The Commission has issued the enclosed Amendment Nos. 51, 51 and 48 for License Nos. DPR-38, DPR-47 and DPR-55 for the Oconee Nuclear Station, Units 1, 2 and 3. These amendments consist of changes to the Stations common Technical Specifications and are in response to your request dated June 6, 1977.

These amendments revise the common Oconee Technical Specifications to incorporate changes to the Oconee Unit 2 pressurization heatup and cooldown limitations.

ATTACHMENT TO LICENSE AMENDMENTS

SAFETY EVALUATION BY THE OFFICE OF NUCLEAR REACTOR REGULATION

UNIT 2
REACTOR COOLANT SYSTEM
NORMAL OPERATION HEATUP LIMITATIONS
APPLICABLE FOR FIRST 4.0 EFPY
OCONEE NUCLEAR STATION

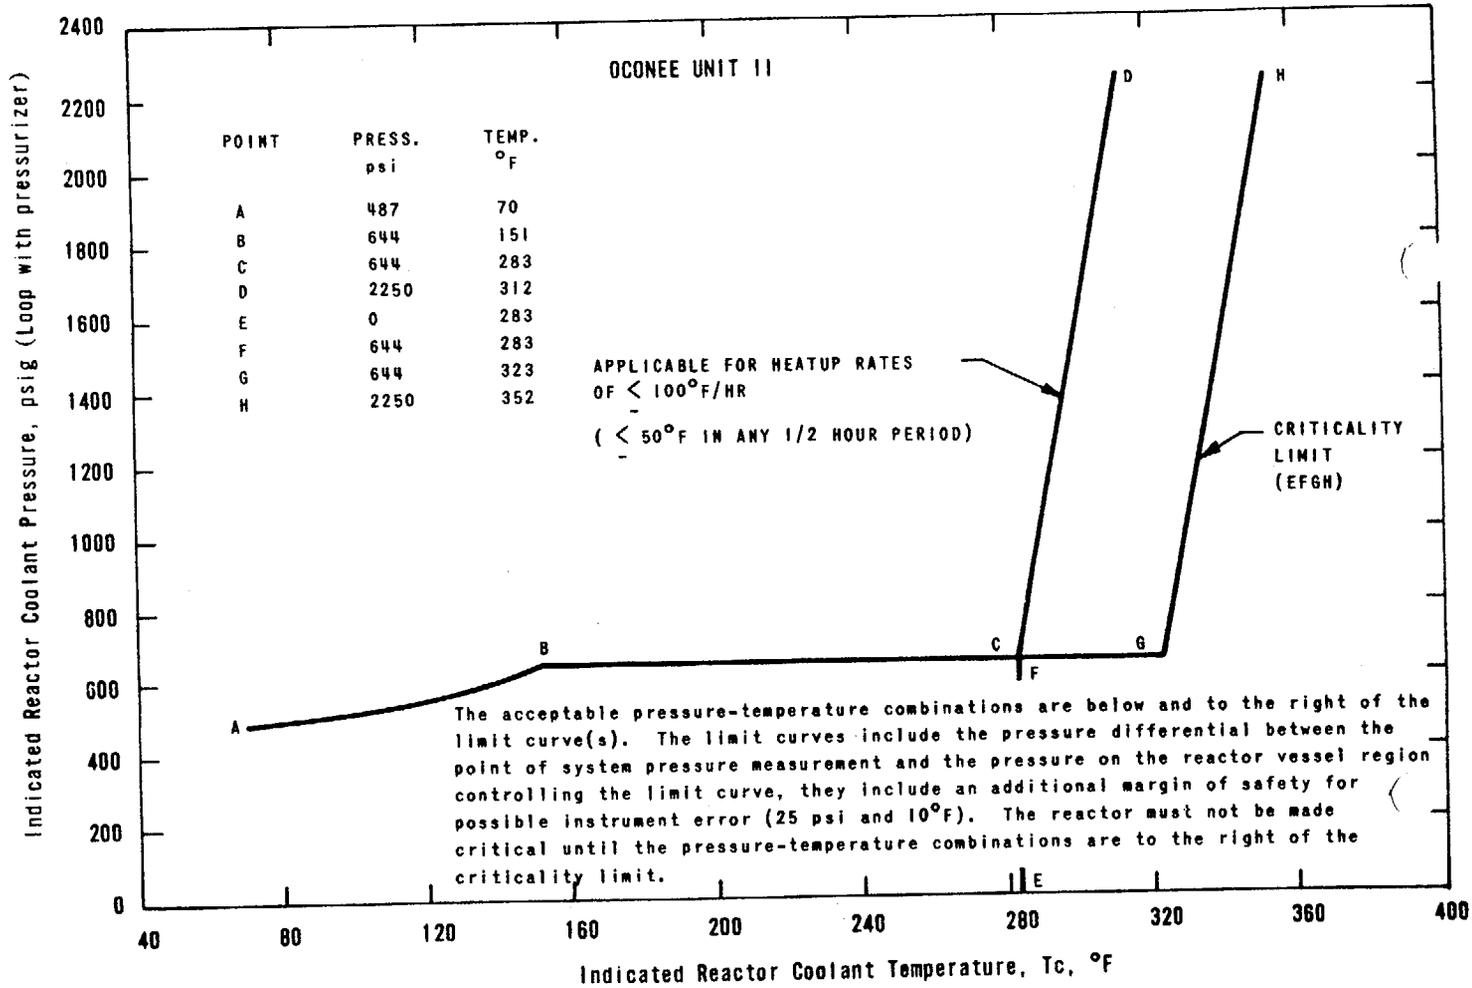
The proposed revised Oconee Unit 2 pressure-temperature operating limit curves, Figures 3.1.2-1B, 3.1.2-2B and 3.1.2-3B are based on data from Babcock & Wilcox Report, "Analysis of Capsule OCII-C From Duke Power Company Oconee Nuclear Station, Unit 2, Reactor Vessel Materials Surveillance Program," BAW-1437, dated May 1977. The proposed curves are projected for 6 EFPY.

We have reviewed BAW-1437 and the proposed pressure-temperature operating limit curves. Capsule C from Unit 2 contained specimens of weld metal WF 209-1. This weld is not identical to the welds in Oconee Unit 2. However, this weld has a similar chemical composition and was made using weld procedure similar to those for high copper Oconee vessel welds. Therefore we conclude that the properties of the limiting weld metals in the Oconee reactor vessels will be affected by irradiation in a manner similar to these WF 209-1 specimens. Also, the Oconee Unit 2 and Unit 1 neutron flux, flux spectrum and weld material mechanical properties are similar. The Oconee Unit 1 pressure-temperature limits were approved on February 23, 1977, and were applicable for 4 EFPY. For the reasons stated in our Safety Evaluation Report issued February 23, 1977 on Oconee Unit 1, we have concluded that the proposed temperature operating limit curves for Unit 2 should also be limited to 4 EFPYs of operation.

Based on our review of the Oconee Unit 2 pressure-temperature limits and the similarity of the Oconee Unit 2 and Unit 1 designs, materials and operating conditions, we conclude that the operating limits proposed for Unit 2 are in conformance with Appendix G, 10 CFR Part 50, and are therefore acceptable.
